ADDENDA

Date	May 15	2009
Addenda Number	#1

REQUEST FOR PROPOSALS FOR FIRE HOUSE IMPROVEMENTS, PHASE III, ENGINE COMPANY NO. 14, 25 BLUE HILLS AVENUE, HARTFORD, CT		
RFR NUMBER	BID NO 4421	DPW F03-09D
DUE DATE	2:00 PM	BIDDATE May 21, 2009

ADDENDUM NO. 1

DRAWING TITLE
PARTIAL FLOOR PLAN -
KITCHEN

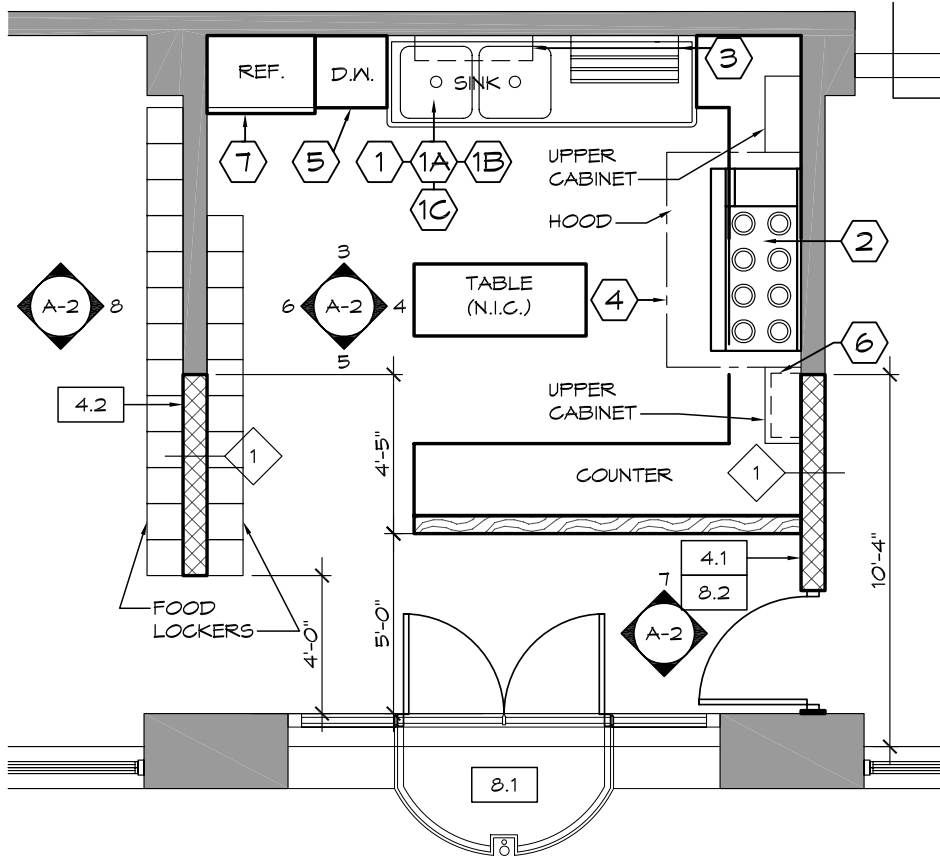
1. Specification Section 105113 METAL FOOD LOCKERS enclosed with this Addendum
2. SK-1 and SK-2 enclosed with this Addendum

DRAWING TITLE
ROOF PLAN

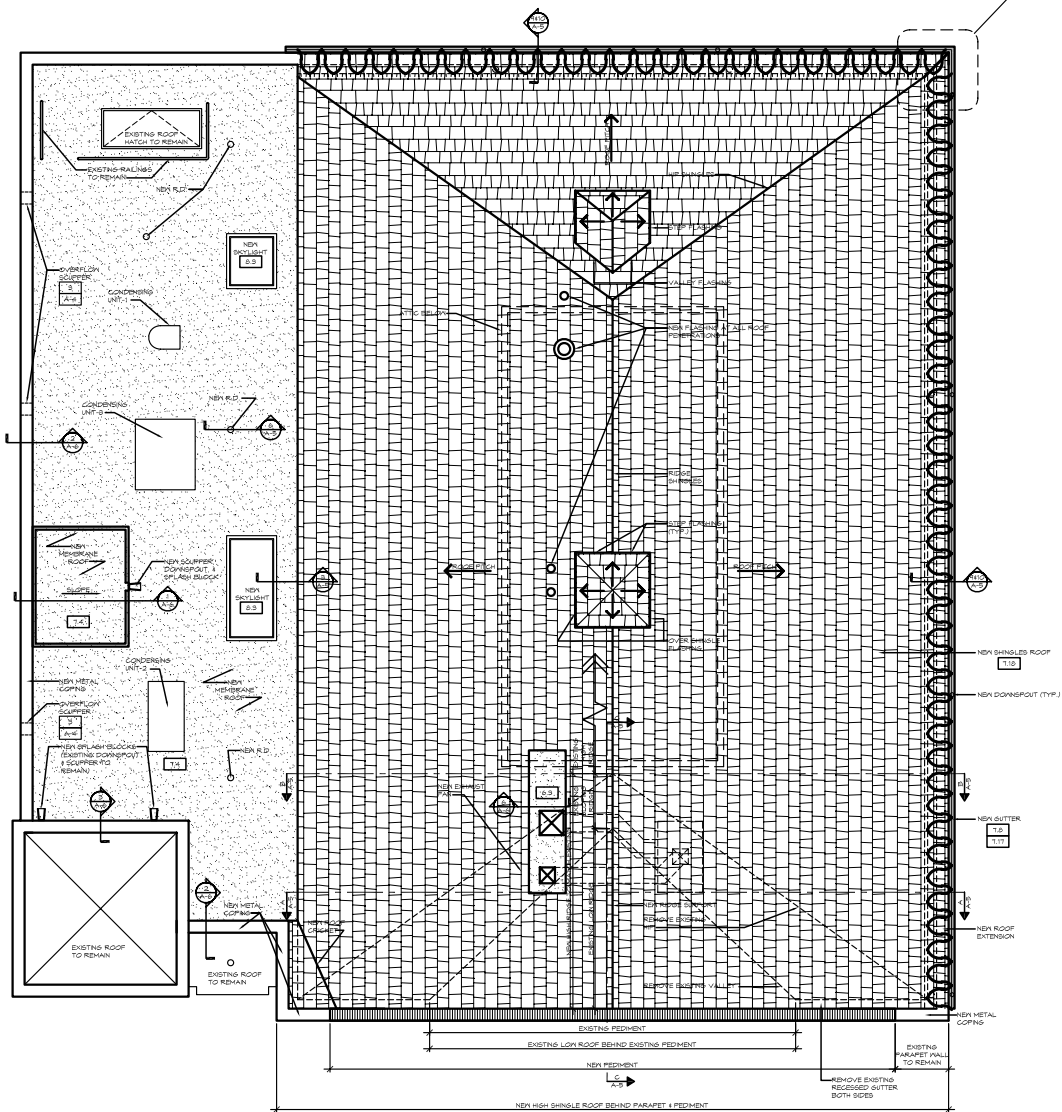
1. In drawing ME-1, First And Second Floor Mech. & Electrical Plans, Dated 4/28/09. **REVISED** the drawing to add seven (7) GFCI, Weather Proof (WP) receptacle at roof for heat tracing of seven (7) downspout. All receptacles shall be circuited together to a 20A-1p breaker in existing panel EP2. Provide 20A, 1P breaker. Coordinate Exact downspout locations with Plumbing and Architectural drawings
2. In drawing ME-1, First And Second Floor Mech. & Electrical Plans, Dated 4/28/09. **REVISED** drawing to add one GFCI, Weather Proof (WP) receptacle at roof for gutter heat tracing. Receptacle shall be located near the beginning of the new gutter (near column A-2). Receptacle shall be circuited to a 20A, 1P circuit breaker in existing panel EP2. Provide 20A, 1P breaker. Coordinate exact gutter location with architectural drawings.

1. In Plumbing Specifications, add note #24 to read as follows: Roof Drain, JR Smith Model # 1010, provide with vandal-proof cast iron dome, under deck clamp and sump receiver, size to match existing.
2. In Plumbing Specifications, add note #25 to read as follows: Provide new heat trace cabling at all new gutter systems and downspouts at building

exterior, refer to Architectural and Plumbing drawings for all gutter and down spout locations. Heat trace cable, Raychem Winter-Guard H908, 120v, self regulating, plug-in connection, maximum length per circuit shall be 250 feet, 16 gauge, nickel plated copper conductor, thermoplastic elastomer inner jacket, metallic over-braid and thermoplastic outer jacket, 3 watts per foot, UL listed. Install as required by all of the manufacturers written installation instructions.
